Subject: Disapproval of the Groundwater Flow Model Report

Attachment A: Joint Agency Deficiencies on the Groundwater Flow Model Report, Red Hill Bulk Fuel Storage Facility, dated March 25, 2020

HAWAII DEPARTMENT OF HEALTH TECHNICAL REVIEW

Figure C-6: Alternative Representation of Saprolite-Basalt Relationships

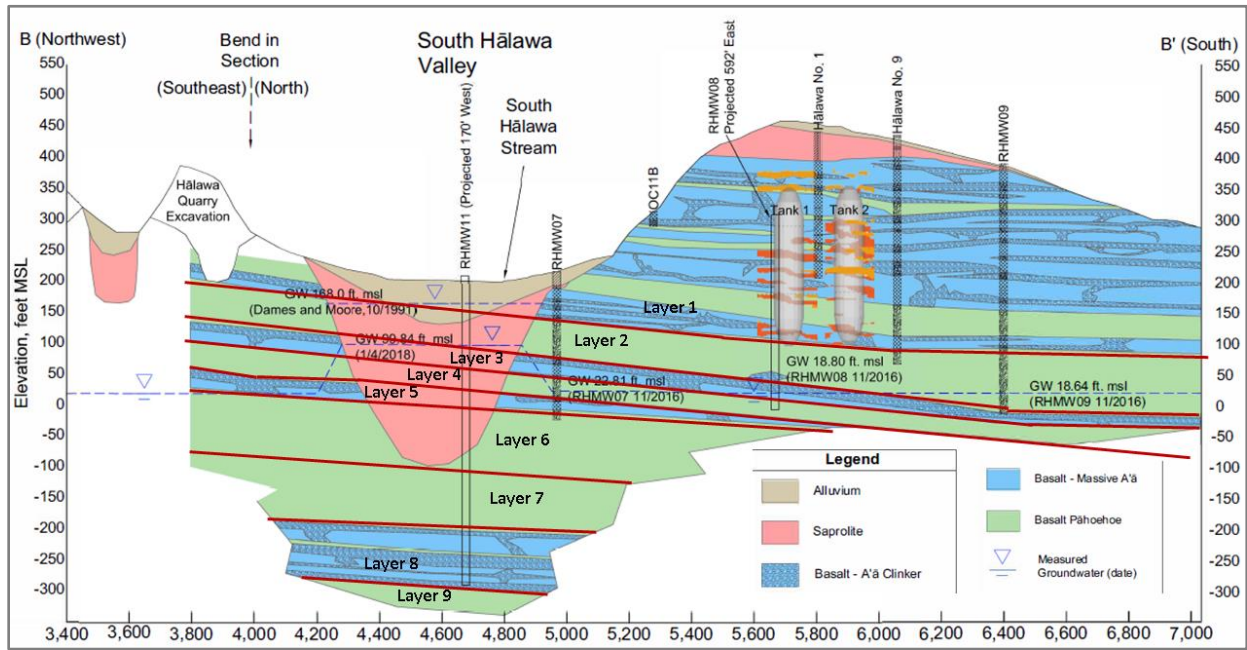
As a result, Layer 4 represents basalts adjacent to and beneath the saprolite. This is accomplished by deforming (lowering) the top and bottom elevations of the layers representing basalt in the areas where saprolite is present. At RHBSF, however, this may allow for the simulation of flow within numerically contiguous basalt units beneath saprolites that are actually discontinuous (so that flow is inhibited) in the field. The saprolites formed by the weathering of basalts in such a manner that the saprolite cuts vertically downward into the stratified and sinuous basalt flows (**Figure C-5**, left panel). As a result, lateral movement in the field within otherwise contiguous basalt flow zones can be laterally impeded. However, in the groundwater models this impedance appears to be reduced by deforming layers beneath the saprolite rather than bisecting it (**Figure C-5**, right panel). Some impedance remains, however, rather than being controlled primarily by lateral conductivity contrasts between basalt and saprolite (and secondarily the basalt vertical conductivity), the simulated flow distribution it is controlled by a combination of (local) bulk transmissivity reduction (and secondarily the basalt vertical conductivity). Support for this includes the apparent relative insensitivity of simulated pathlines in many areas to the depth and conductivity of the saprolites. Different, more plausible, results would likely be obtained by constructing the model using more uniform layers aligned with the dip and using parameter value contrasts to represent changes in material type and HSU (**Figure C-6**).
